DEVELOPMENT APPLICATION

APPLICATION NUMBER:	PLN-25-250
PROPOSED DEVELOPMENT:	Partial demolition, additions and alterations to Powder Coating (Manufacturing and Processing)
LOCATION:	8 Knoll Street Glenorchy
APPLICANT:	O2BME Corporate Pty Ltd
ADVERTISING START DATE:	24/02/2026
ADVERTISING EXPIRY DATE:	11/03/2026

PLN-25-250
8 Knoll Street, Glenorchy

In response to your correspondence dated 22 January 2026
I have addressed your requests as follows:

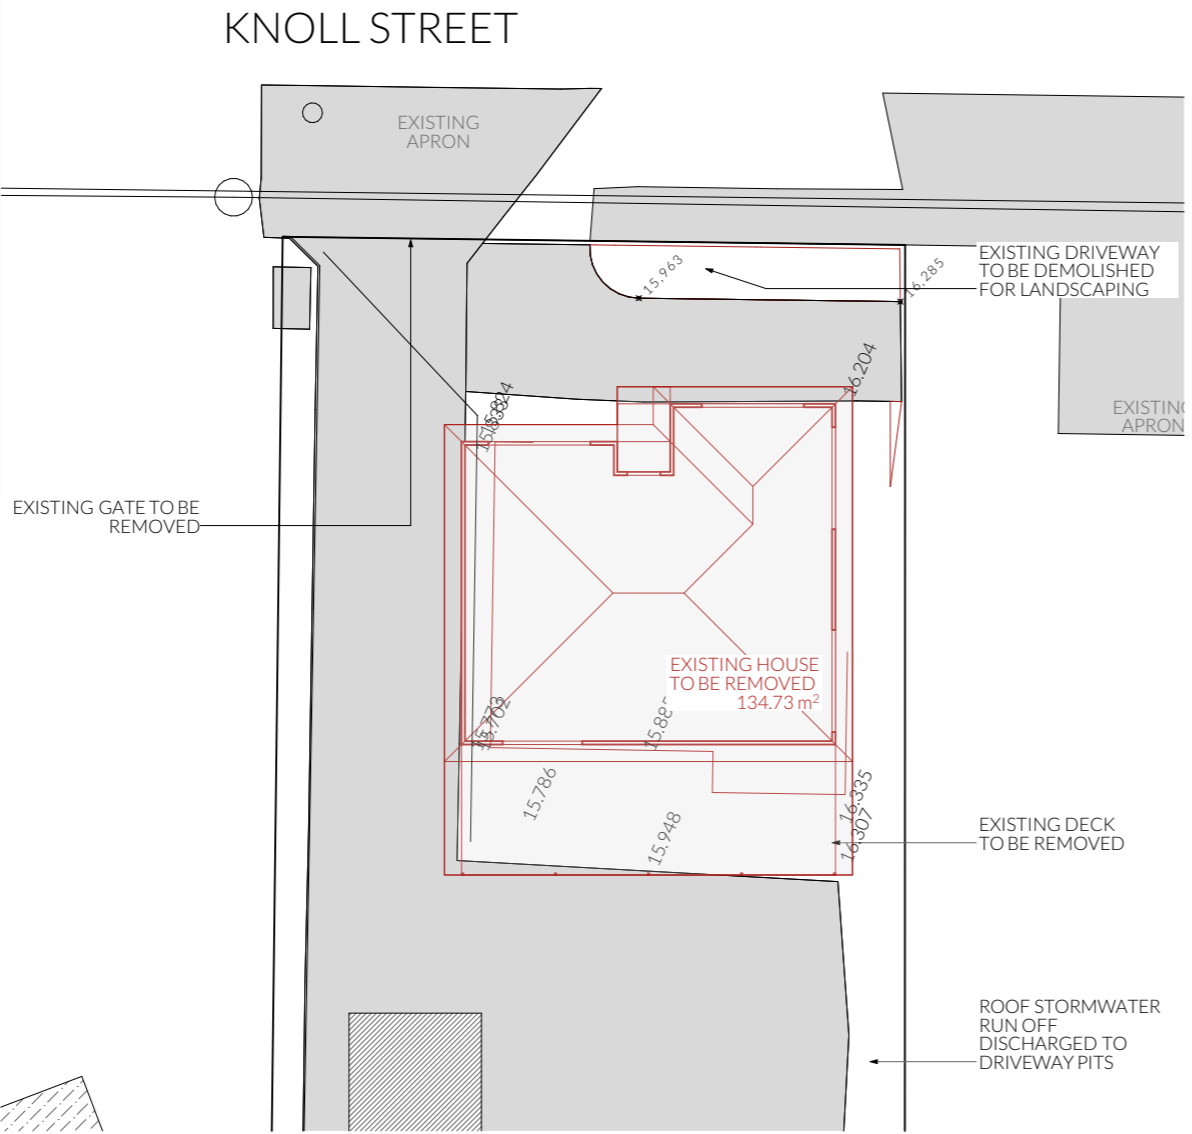
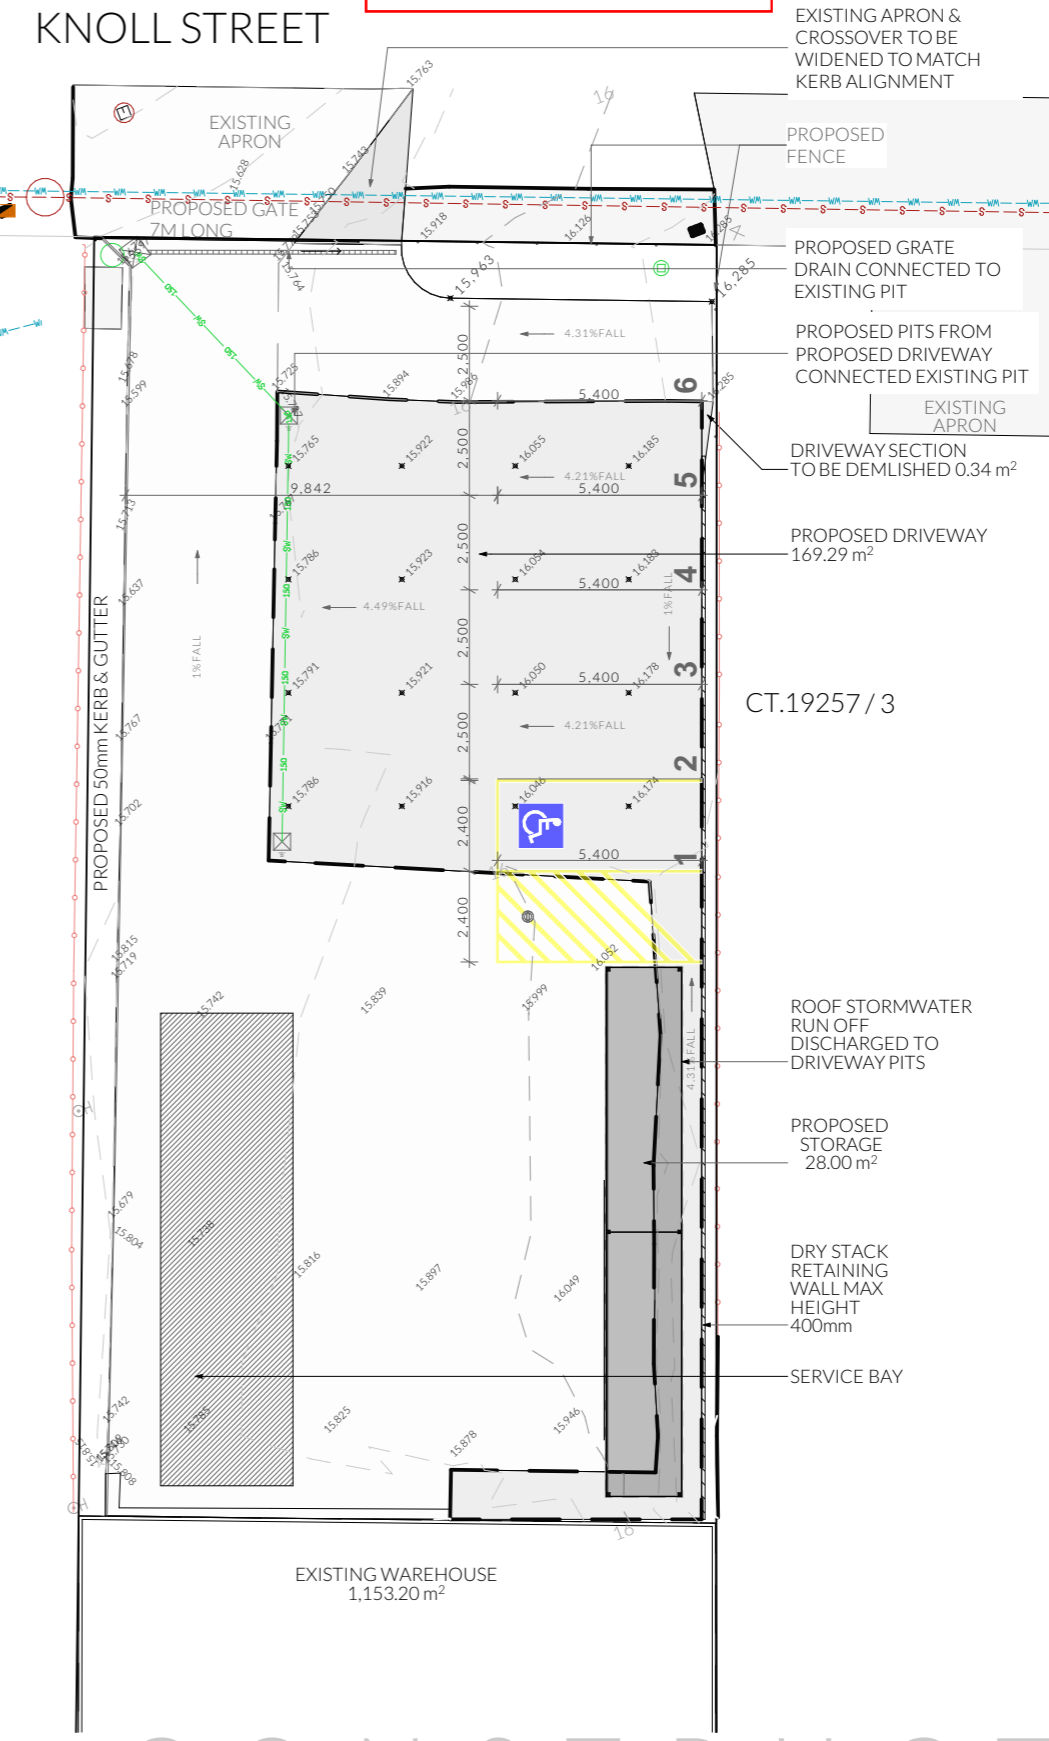
5.	<p>Layout of driveway and parking areas must be in accordance with the AS2890.1:2004 and the Scheme requirements.</p> <p>Please clearly show on the parking plan details of the proposed driveway, access and parking areas including gradients, parking area, spot levels, manoeuvring area, materials, finishing surface and drainage details must be submitted to demonstrate compliance and shall comply with the following:</p> <p>(a) Have car parking space dimensions which satisfy the requirements in Table C2.3.</p> <p>Comment:</p> <p>Partially satisfied. The length of the parking spaces have not been dimensioned.</p>	<p>Please see the updated site plan, which now demonstrates the length of each car space.</p>

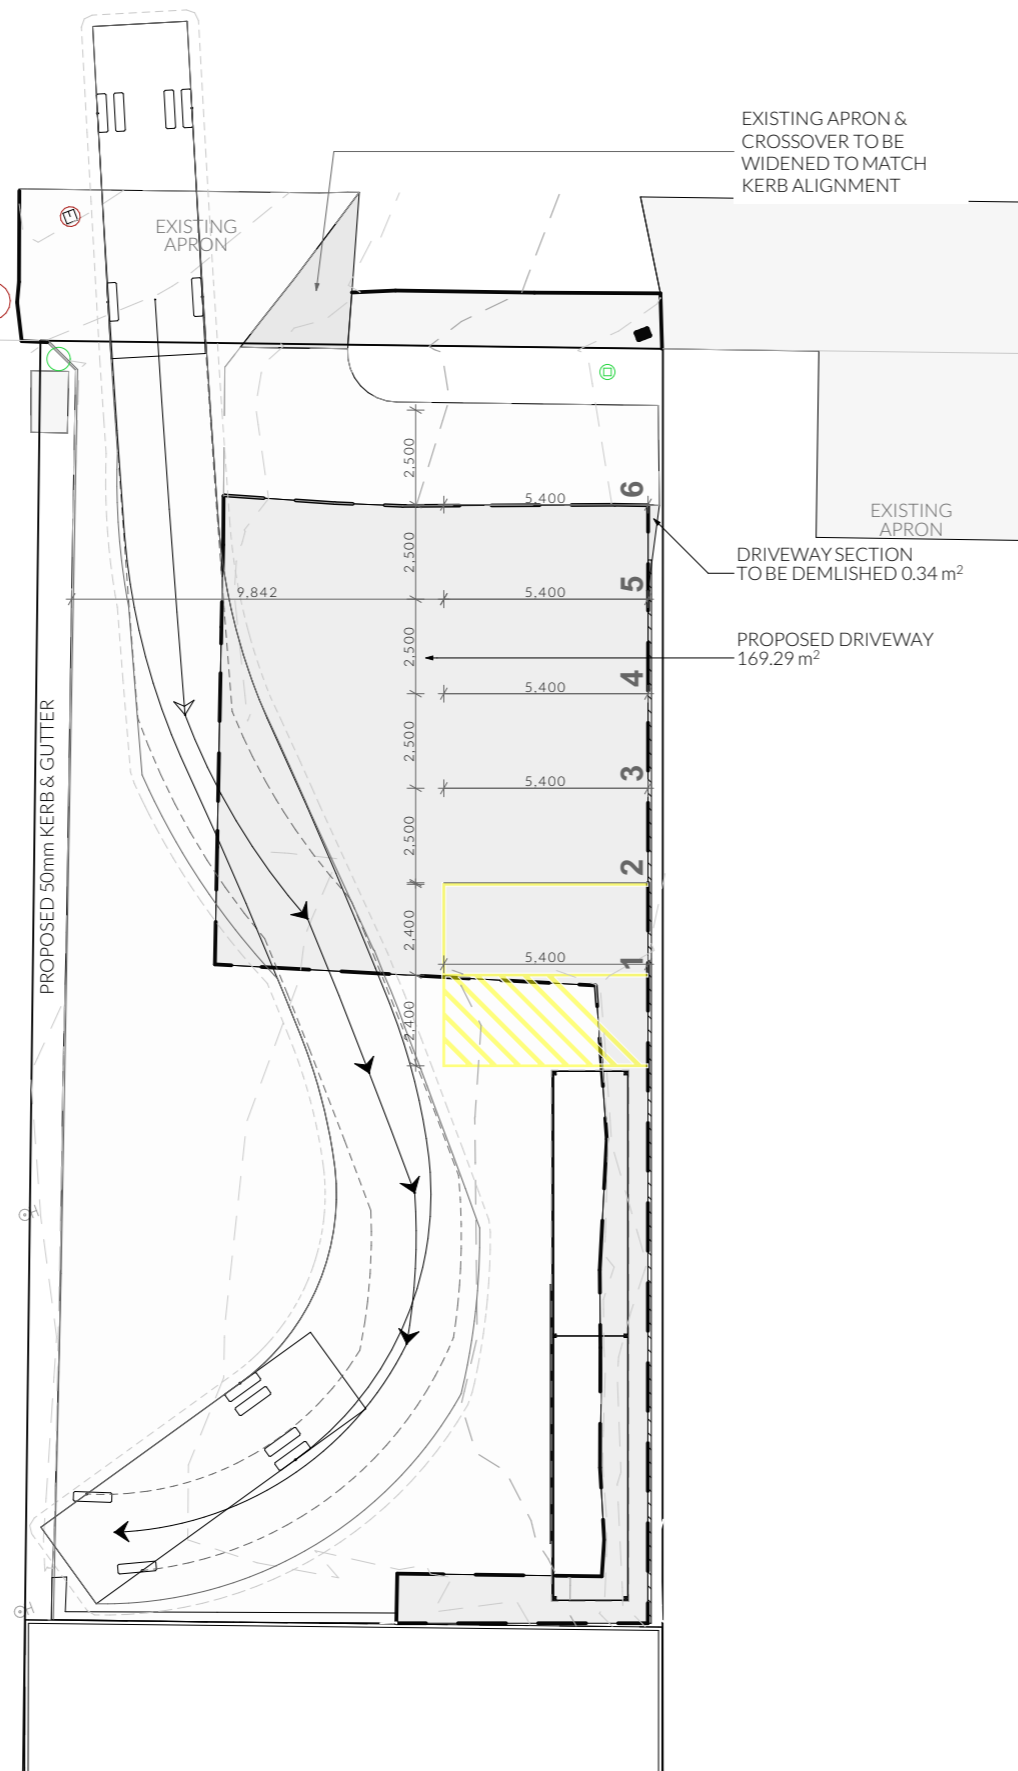
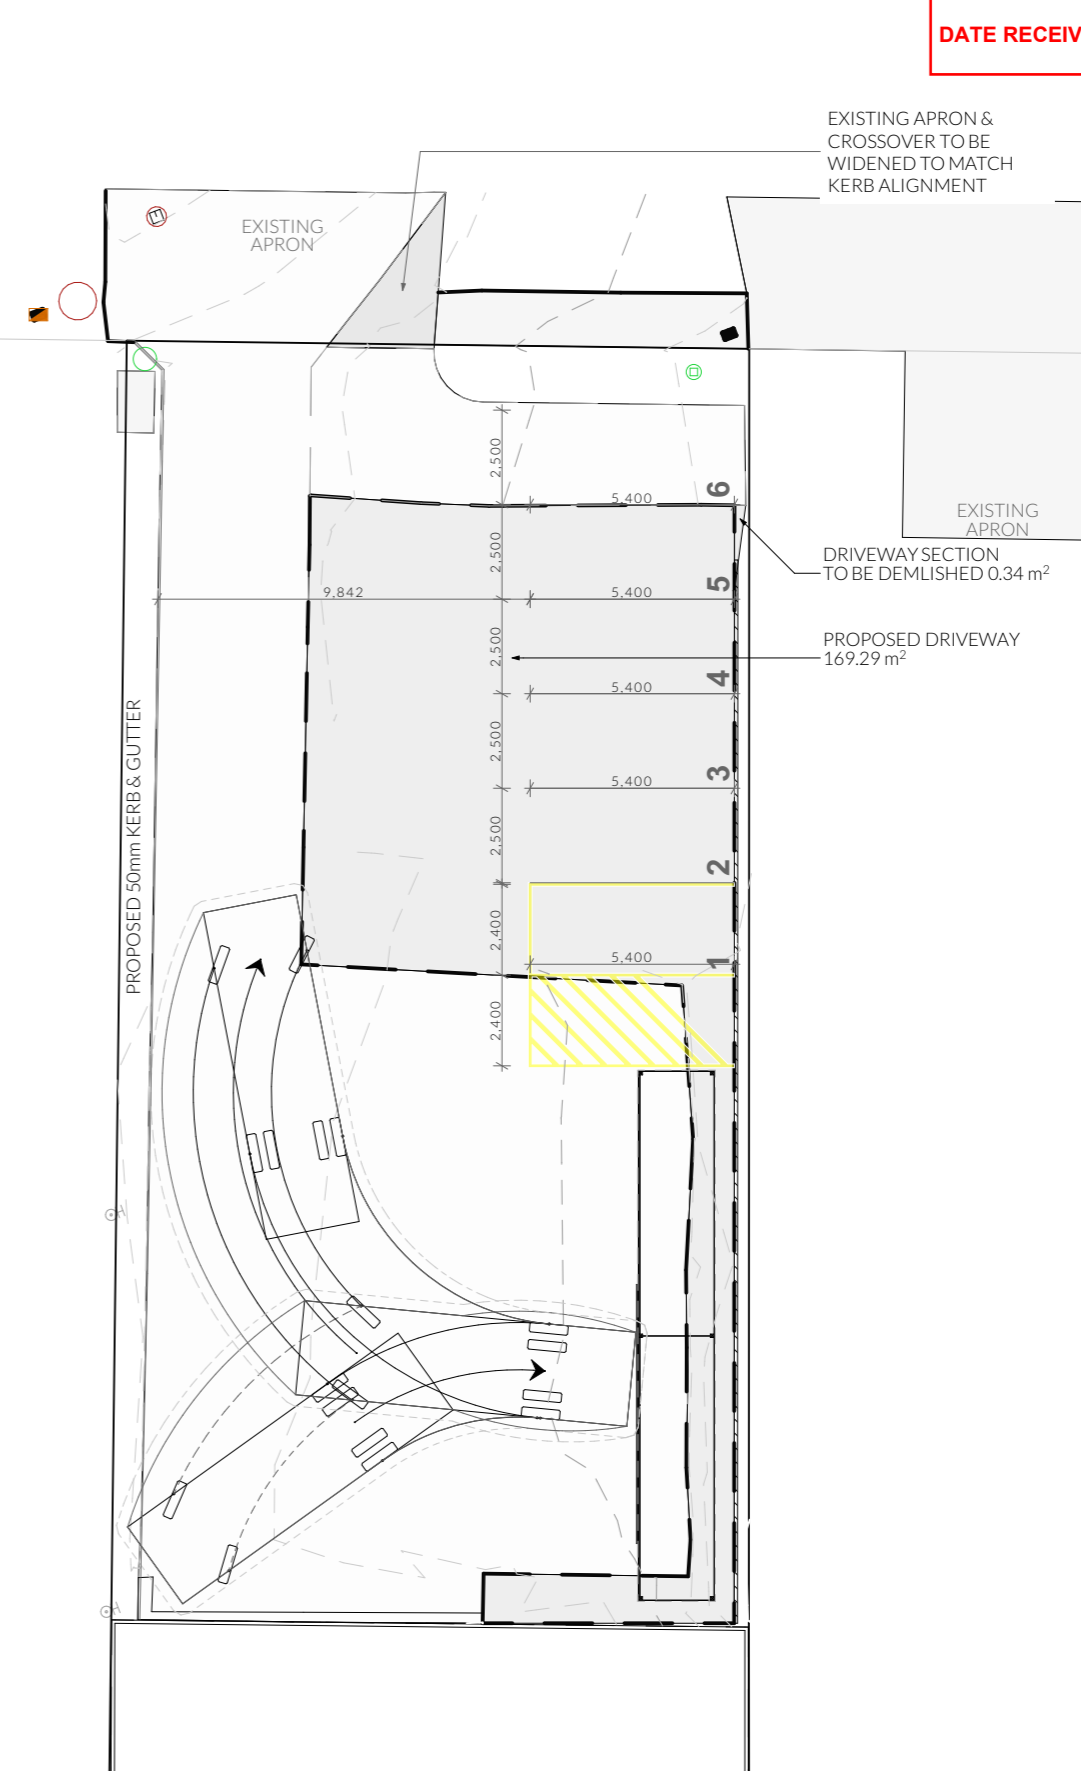
3	<p>Please provide a loading bay in accordance with Clause C.2.5.4 – Standard A1.</p> <p>Comment:</p>	<p>Please see the additional documents demonstrating the turning requirements for an MRV vehicle. Refer to Sheet C.03 – Parking MRV.</p>

<p>The proposed loading bay must comply with the loading bay requirements of the planning scheme (C2.6.6). The Acceptable Solution must be demonstrated; otherwise, Performance Criteria P1 and P2 must be adequately addressed.</p> <p>If forward entry and exit cannot be achieved, A Traffic Impact Statement (TIS) is required to demonstrate heavy vehicle swept paths. The TIS must demonstrate how vehicles can safely reverse to the road when all car parking spaces in the vicinity of the driveway are occupied.</p> <p>All items relevant to P1 and P2 must be fully considered and addressed.</p>	
4	<p>Please provide a stormwater concept plan showing the capture and disposal of all stormwater run-off from the proposed driveway, parking and any new hardstand areas to Council's approved outlet.</p> <p>Comments:</p> <p>It is not clear how the surface runoff from the red area below can be managed.</p> <p>It is recommended that a trench drain is added within the orange area shown below so all additional runoff can be captured and drained into the proposed pit.</p> <p>Edge treatment needs to be considered. This must be clearly demonstrated in the plans, so no surface runoff can enter to 6 Knoll Street property.</p>	<p>Please see the updated site plan, which now includes additional spot levels and indicates a 4.31% fall.</p> <p>An additional grated drain has been incorporated and connected to the existing stormwater pit.</p> <p>Refer to the site plan for the proposed 50 mm kerb and gutter added along the existing driveway to ensure no surface runoff enters 6 Knoll Street.</p>
